## HISTORIC AND DESIGN REVIEW COMMISSION

July 17, 2019

**HDRC CASE NO:** 2019-340  
**ADDRESS:** 1104 NOLAN  
**LEGAL DESCRIPTION:** NCB 1668 BLK L LOT 9  
**ZONING:** R-5, H  
**CITY COUNCIL DIST.:** 2  
**DISTRICT:** Dignowity Hill Historic District  
**APPLICANT:** JENNY HERNANDEZ/HHGC, LLC  
**OWNER:** JENNY HERNANDEZ/HHGC, LLC  
**TYPE OF WORK:** Construction of a 1-story, single family residential structure  
**APPLICATION RECEIVED:** June 04, 2019  
**60-DAY REVIEW:** August 03, 2019  
**CASE MANAGER:** Edward Hall  
**REQUEST:**

The applicant is requesting a Certificate of Appropriateness for approval to construction a 1-story, single family residential structure on the vacant lot at 1104 Nolan, located within the Dignowity Hill Historic District.

FLOOR PLAN  
SCALE: 1/4" = 1'-0"

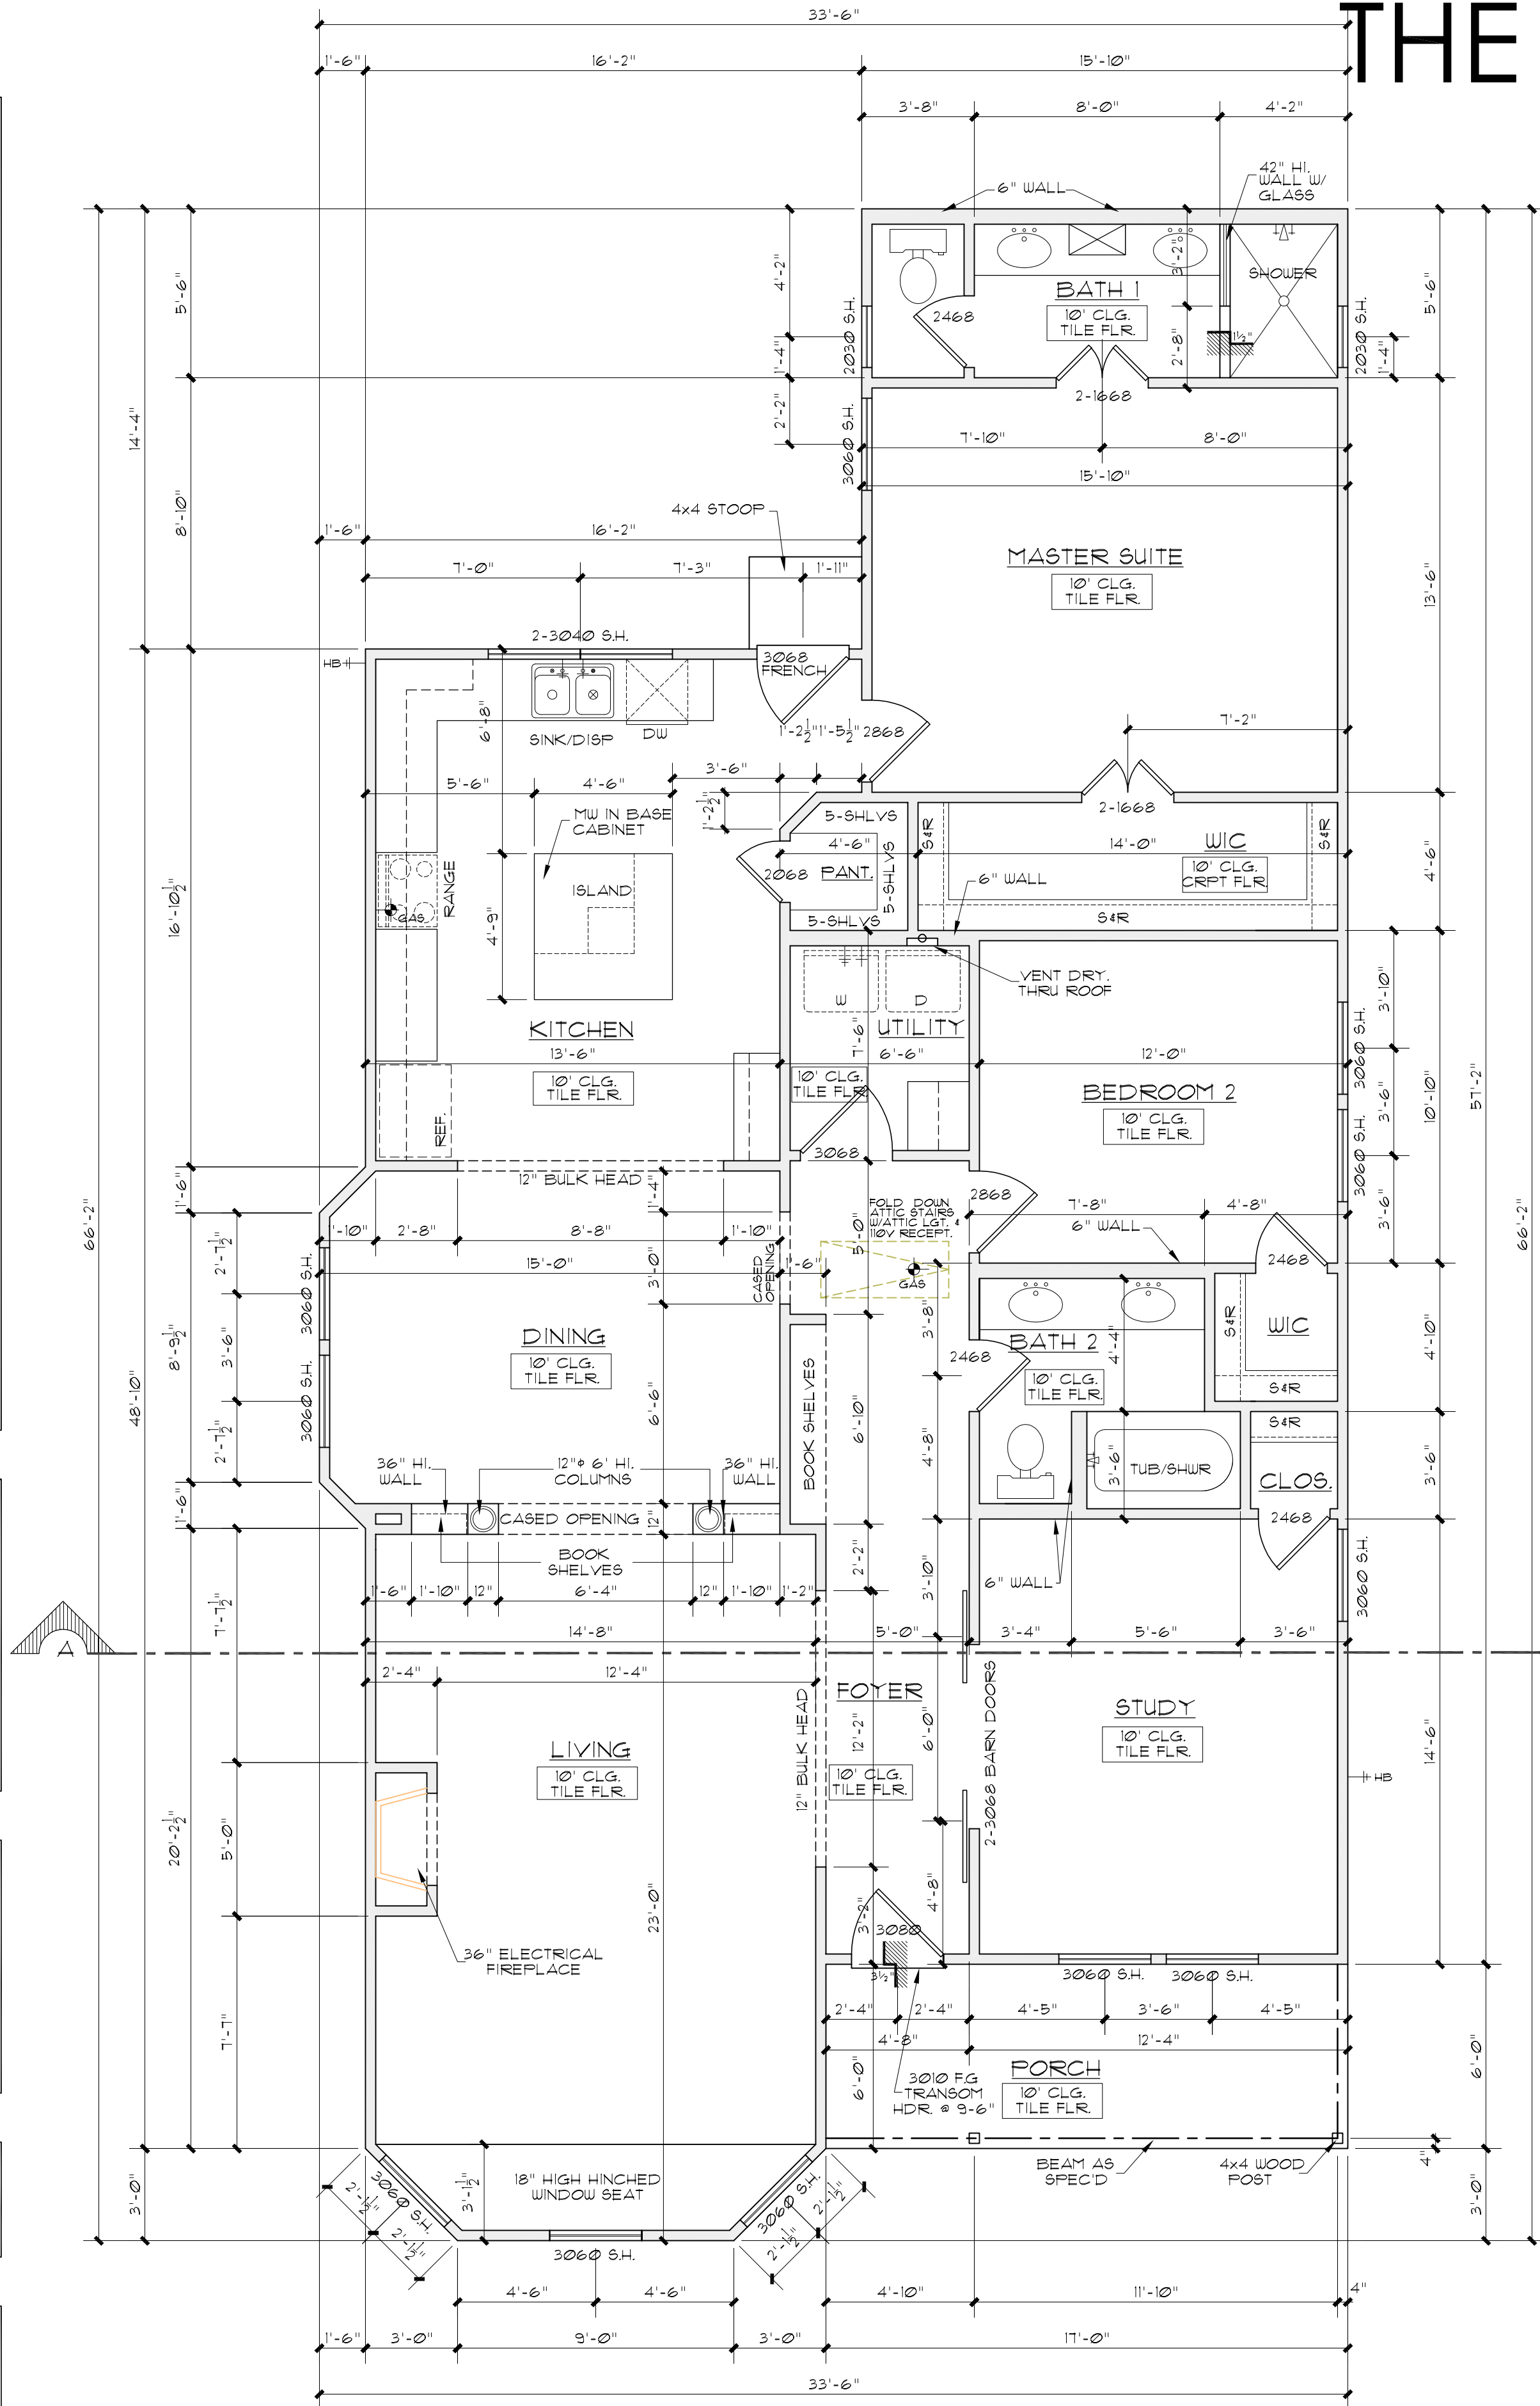
- f. LOT COVERAGE – Per the Guidelines, the building footprint for new construction should be no more than fifty (50) percent of the size of the total lot area. The applicant has proposed a total footprint of 2,040 square feet. The size of the existing lot is 5,250 square feet. Staff finds the proposed footprint to be appropriate and consistent with the Guidelines.

- l. ARCHITECTURAL DETAILS/PORCH – The applicant has proposed architectural details that are generally appropriate for the Dignowity Hill Historic District. Staff finds that the applicant should increase the proposed front porch depth from three (3) feet, to at least six (6) feet in depth; however, staff finds that this should be accomplished without reducing the distance from the front face of the porch to the front face of the projecting bay. Additionally, staff finds that the proposed porch columns should feature a width and depth of at least six (6) inches.

- vi. That the proposed front porch depth be increased to at least six (6) feet in height and that this be accomplished without reducing the distance from the front face of the porch to the front face of the projecting bay as noted in finding l. Additionally, staff recommends that the proposed porch columns feature a width and depth of at least six (6) inches.

SITE PLAN  
SCALE: 1" = 10'-0"

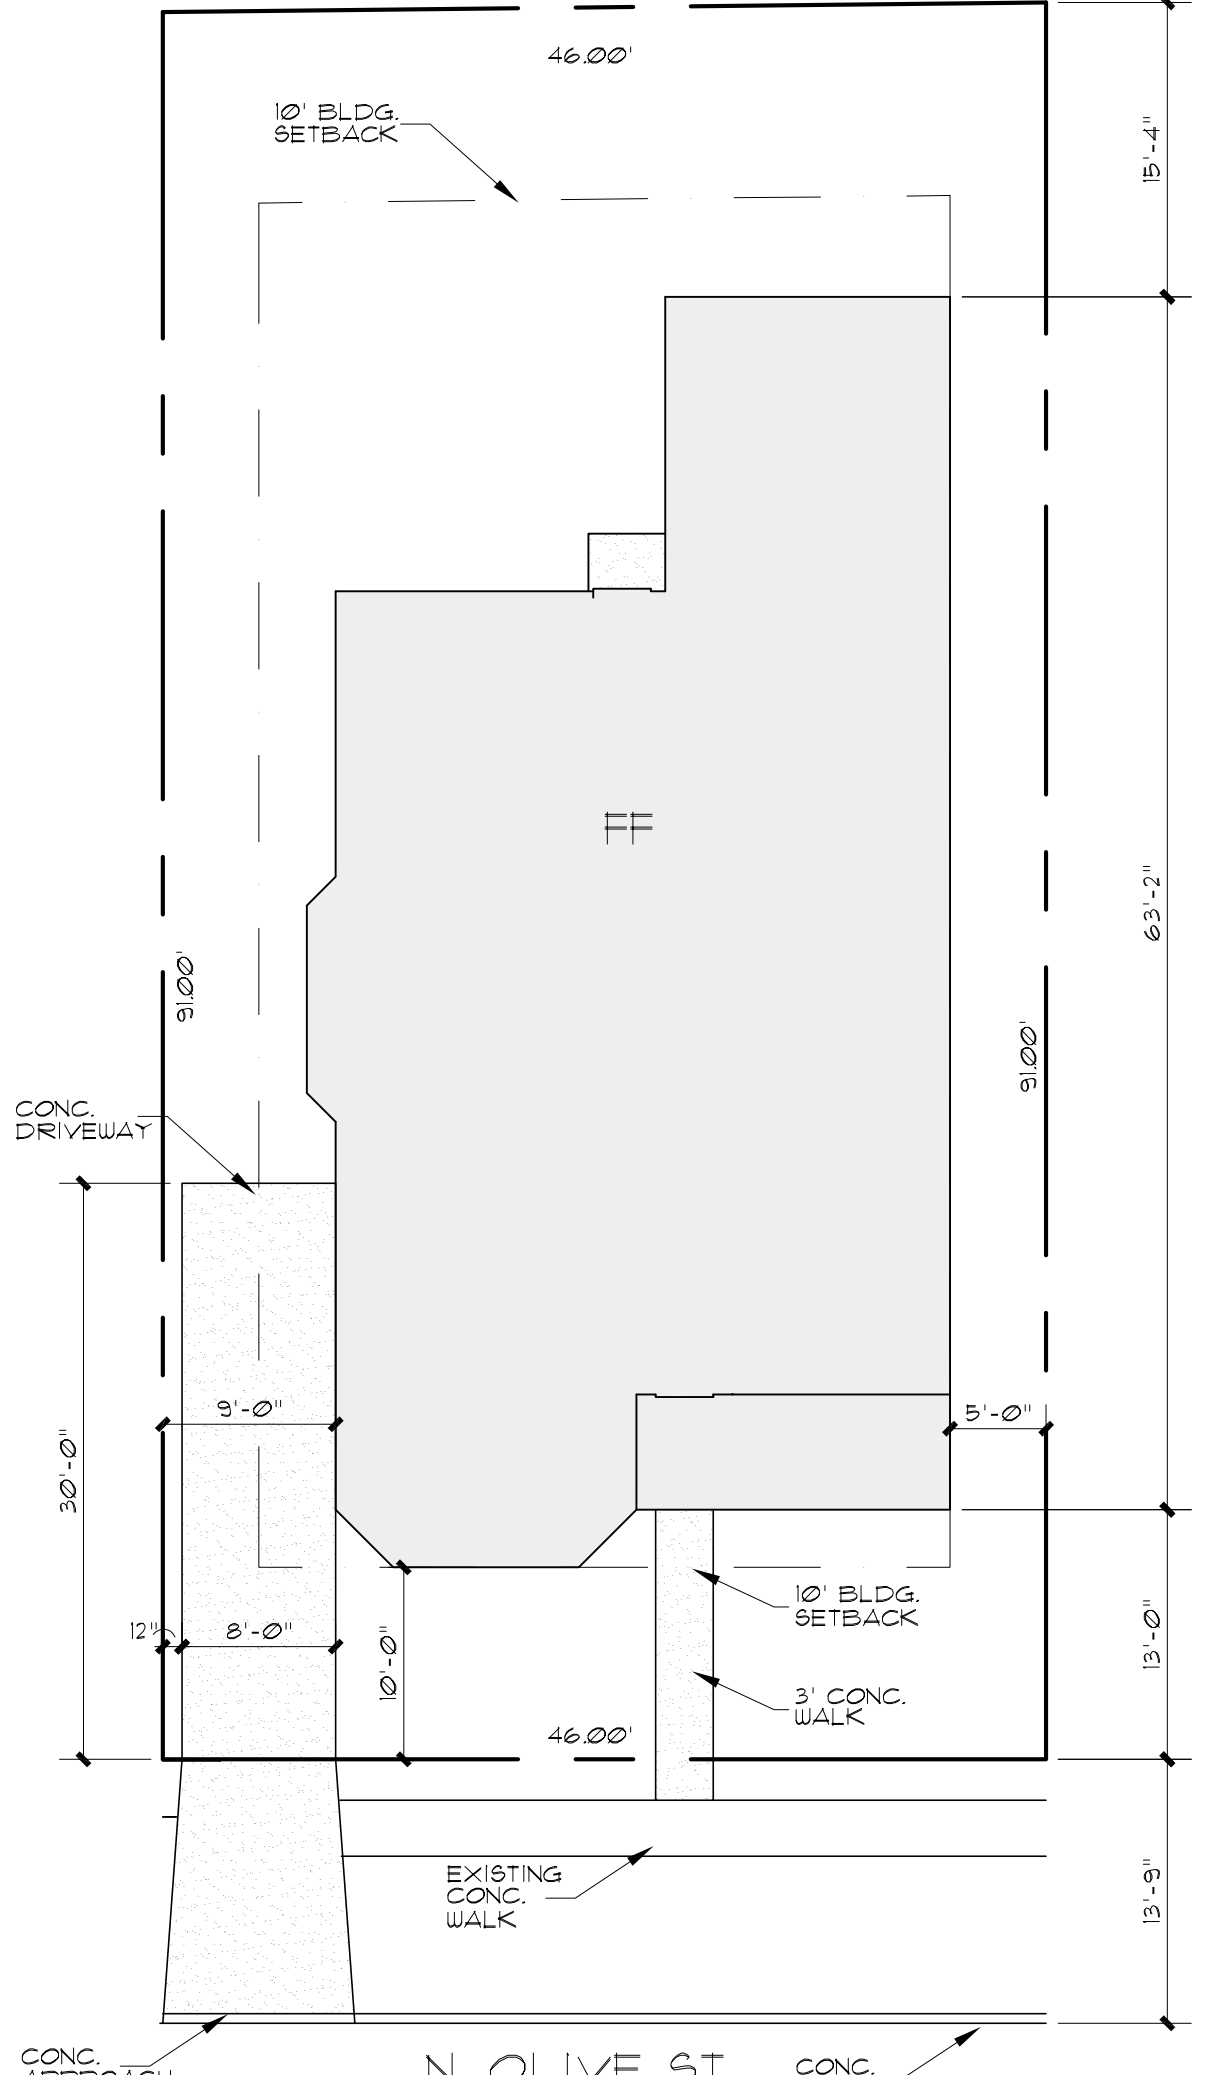
- b. SETBACKS & ORIENTATION – According to the Guidelines for New Construction, the front facades of new buildings are to align with front facades of adjacent buildings where a consistent setback has been established along the street frontage. Additionally, the orientation of new construction should be consistent with the historic examples found on the block. Staff finds that the proposed new construction should feature a setback that is equal to or greater than the adjacent historic structure, including the porch and porch roof. In response, the applicant has proposed to reduce the depth of the front bay in order to meet the setback requirement. Staff finds that this results in an architectural form that is inconsistent with those historically found within the district. Staff finds that the applicant should explore ways to meet the front setback requirement while maintaining a more traditional building form.

- c. SIDE SETBACK – The applicant has noted a side setback on the west property line of only three (3) feet. The applicant is responsible with acquiring any variances needed for a setback that is less than the required five (5) feet, per zoning standards.

- m. DRIVEWAY – The applicant has proposed a concrete driveway to feature twelve (12) feet in width. The

applicant has submitted an updated site plan noting a driveway of ten (10) feet in width.

- i. That the proposed new construction feature a setback that is equal to or greater than the adjacent historic structure, including the porch and porch roof as noted in finding b. This should be accomplished while maintaining a traditional form for the front bay.
